RECEIPT DATE: 4/5/18 **ONSITE SEWAGE DISPOSAL SYSTEM** P 562950

SEPTIC SYSTEM
INSTALLATION SITE PLAN
LOT 2
15305 GALAXY DRIVE
FAIRLANE FARMS

**HOUSE LOCATION
 DRAWING**

**SEPTIC SYSTEM
INSTALLATION SITE PLAN**

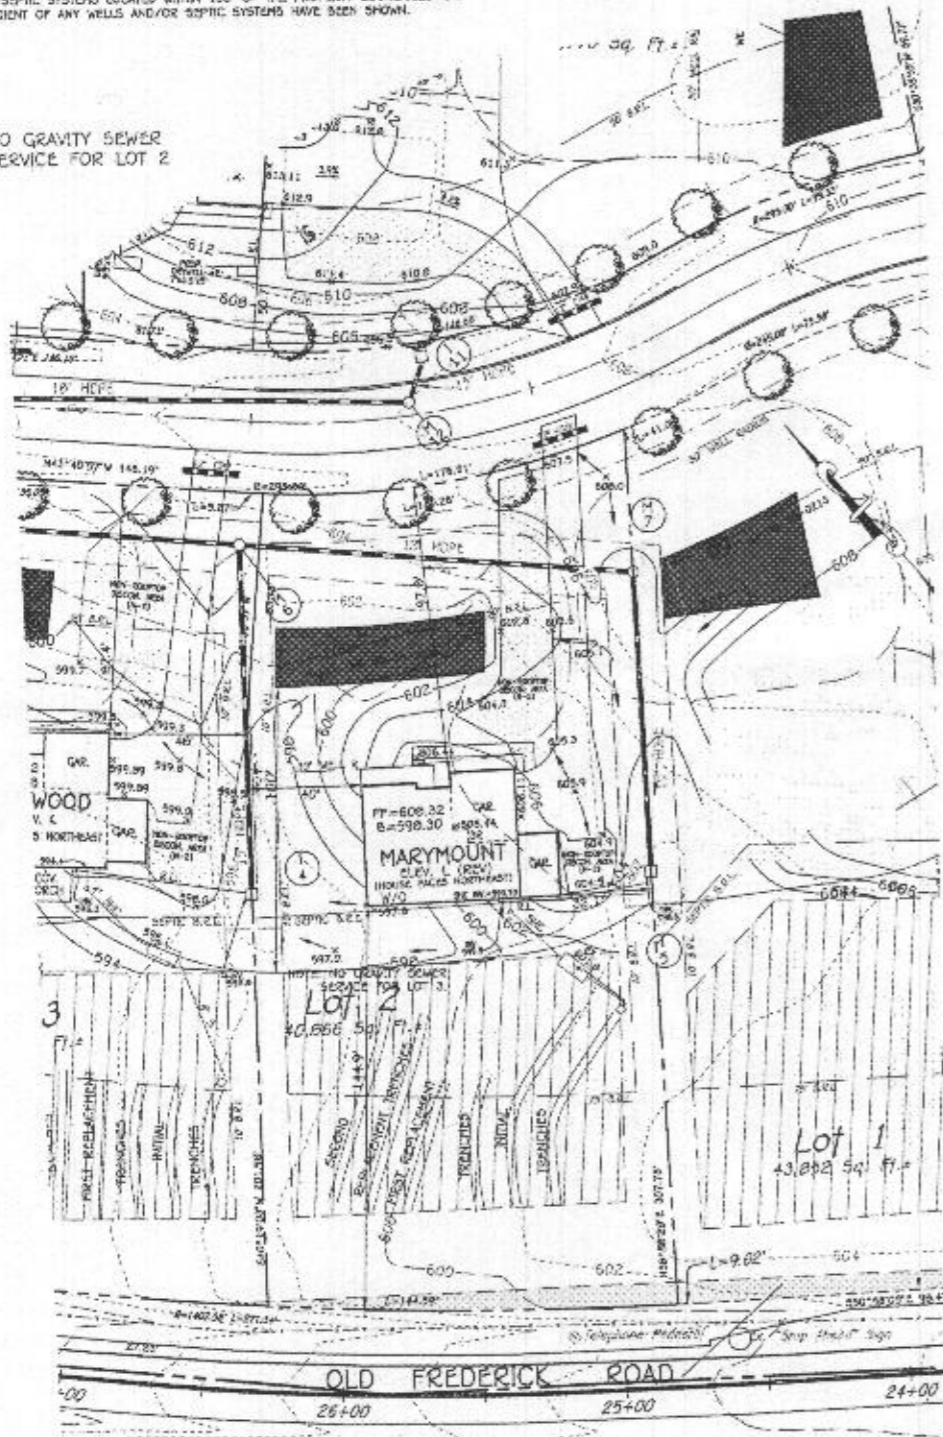
5/4/18 Met S. Carroll on site for layout. SDA corners + tank staked. Shot contour and trenches do not have as much bend as shown on the plan. Turn tank to fit in trenches at upper part of SDA. S. Carroll to install a check valve before clo at house per request of homeowner. (SC)

5/10/18 Trenches complete. T2 left open for inspection + T1 left open @ ends. 3' wide, 3.5-4' to stone. Levelled speed levelers @ D-box. Check valve installed before first clo. (SC)

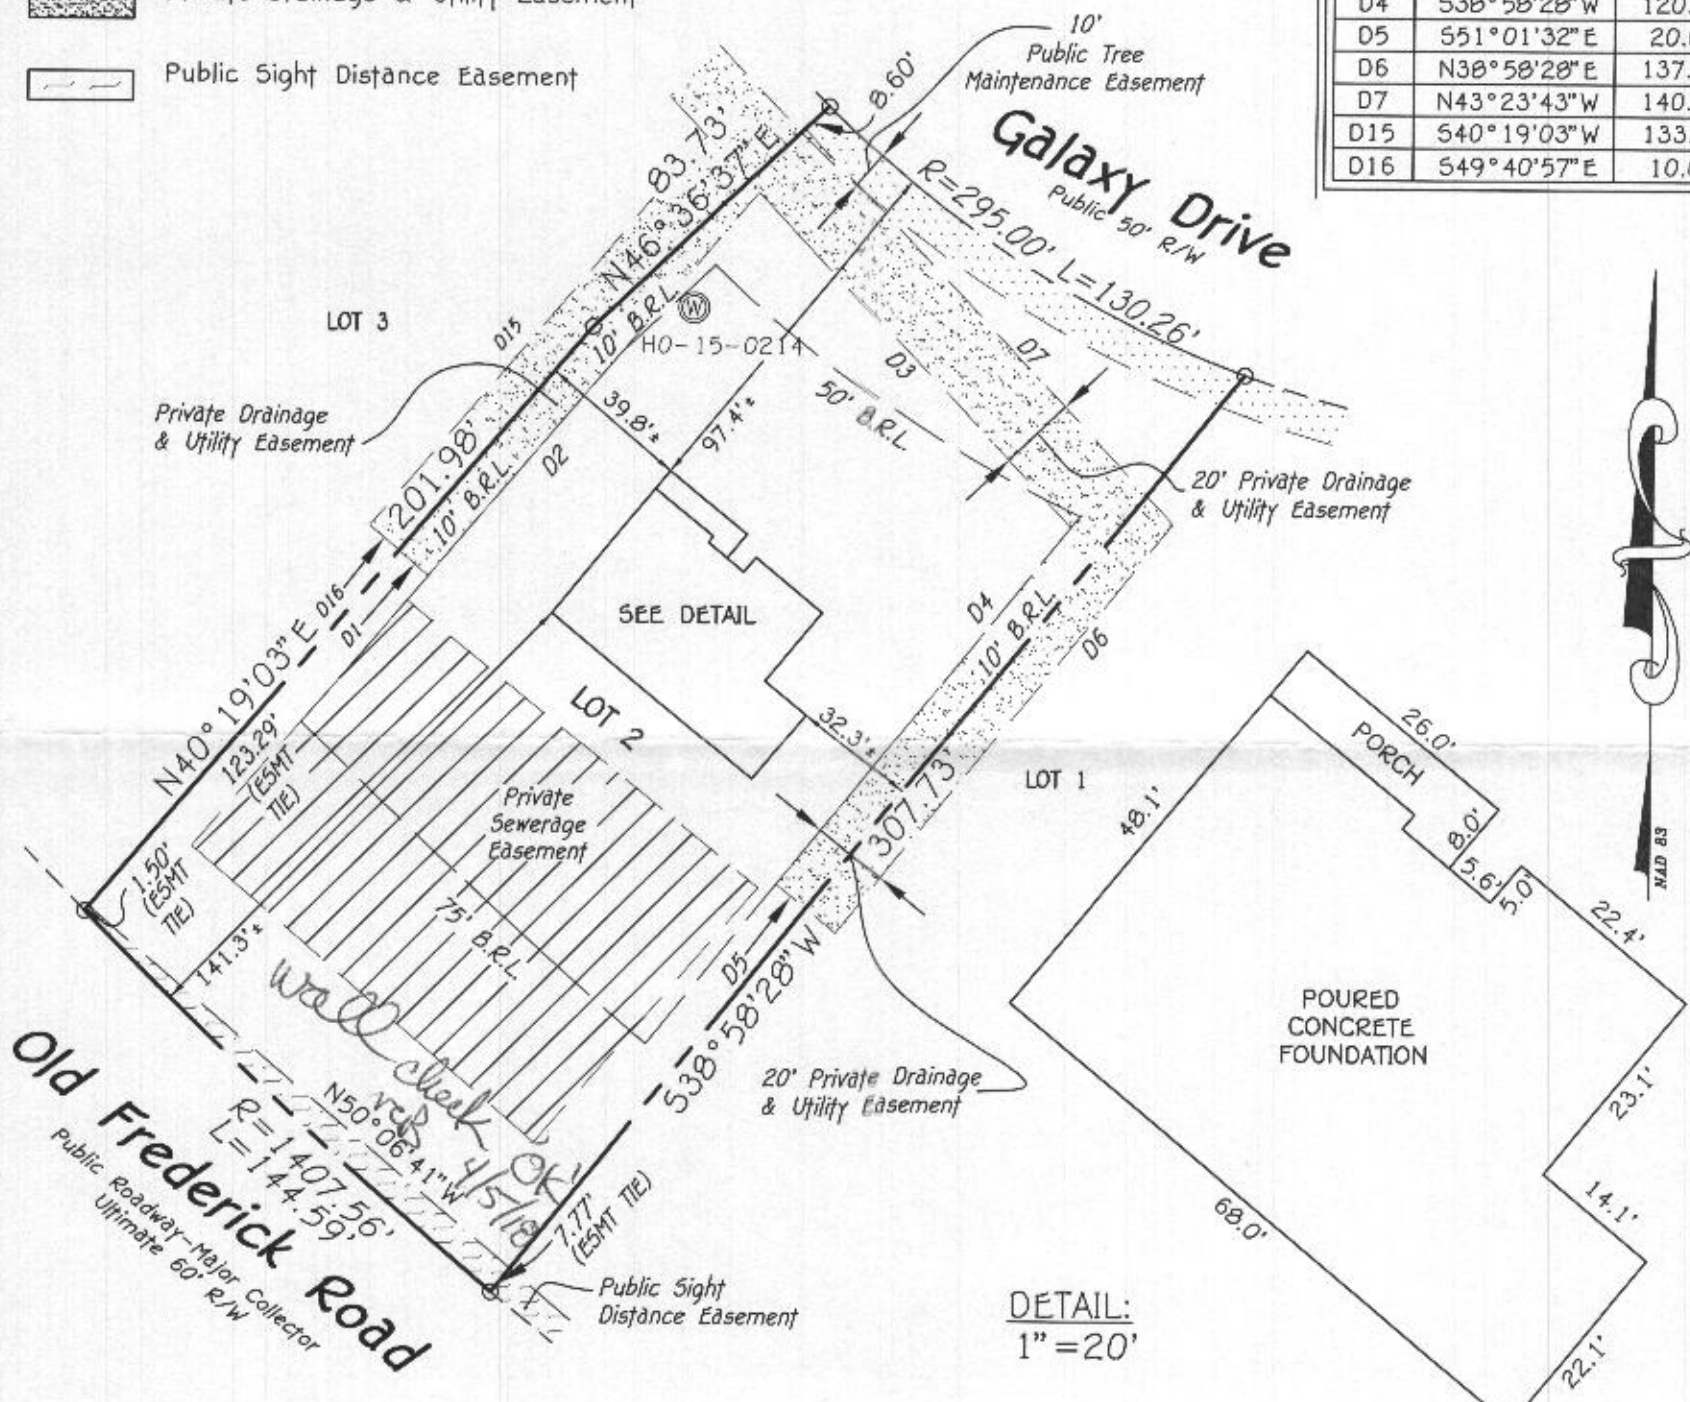
The building permit site plan does not match the OSDS Plan (i.e. well box 30 foot setback to front porch). Please revise.

Yes, the porch must fall outside the 30 foot well radius on the OSDS Plan and BP Site Plan. Lots 2, 3, 4 show porches within the 30 foot well radius.

Quick question for you. Is the front porch on Lots 3 and 4, poured concrete porches? If so, then they're considered part of the foundation and must fall outside the 30 foot well radius.

Here are 6 new copies of the permit (plot) site plan (house has been adjusted a few feet back, at the request of the Hank Oswald at the Health Dept.), so that the front porch is outside the 30 ft. well box radius. Please let me know if you have any questions.
